In the Matter of
Entergy Nuclear Operations, Inc.
(Indian Point Nuclear Generating Units 2 and 3)
Docket Nos. 50-247-LR/50-286-LR

The purpose of this letter is to inform the Licensing Board that, on March 24, 2008, Entergy Nuclear Operations, Inc. submitted Amendment No. 3 to the License Renewal Application ("LRA") for Indian Point Energy Center. As stated in the associated transmittal letter (NL-08-057), LRA Amendment No. 3 includes five attachments. A copy of LRA

Based on discussions with the staff during the NRC inspection, the LRA is revised as described below. (underline – added, strikethrough – deleted)

Figure 2.5-2
IP2 Offsite Power Scoping Diagram

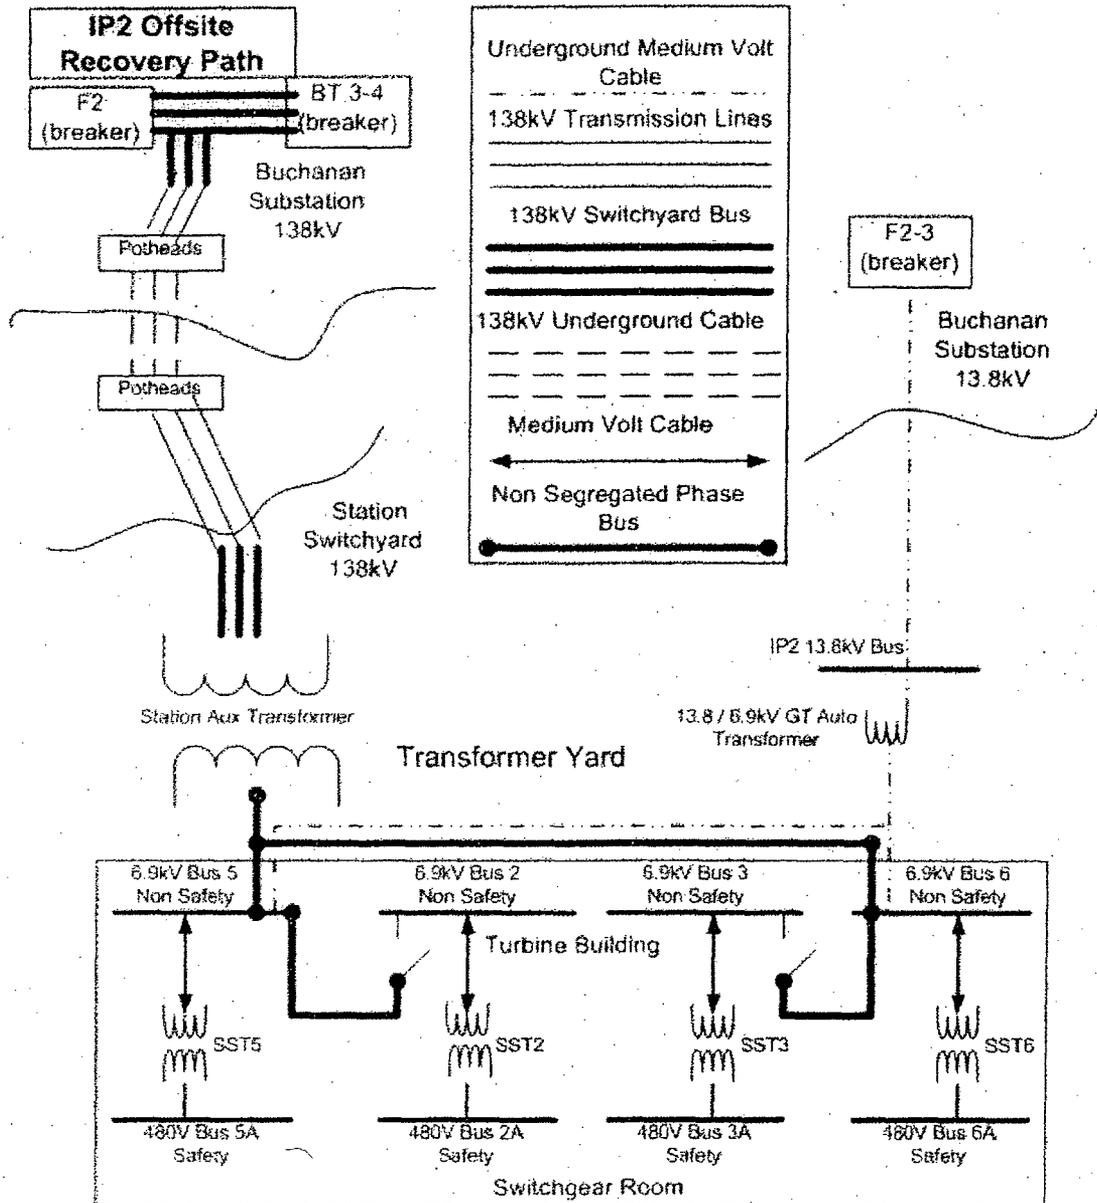
Based on discussion with the NRC Staff on 12/4/07 and industry discussion with the NRC Staff on 12/12/2007 and 1/30/2008, the response to this RAI provided in Entergy Letter NL-07-138, Dated 11/16/2007 is being revised. The only section that requires revision is LRA Figure 2.5-2 and associated discussion.

As shown in the revised LRA Figure 2.5-2, the 6.9 kV buses receive offsite power from either the 138 kV / 6.9 kV station auxiliary transformer or the 13.8 kV / 6.9 kV GT autotransformer. The station auxiliary transformer is connected to the 138 kV Buchanan substation, the primary offsite power source, via switchyard bus, overhead transmission conductors, and underground transmission conductors through ~~motor-operated disconnect F3A~~ switchyard breakers F2 and BT 3-4, which is are located at the Buchanan substation. The GT autotransformer is connected to the 13.8 kV Buchanan substation, the secondary offsite power source, via underground medium voltage cable through breaker F2-3, which is located at the Buchanan substation.
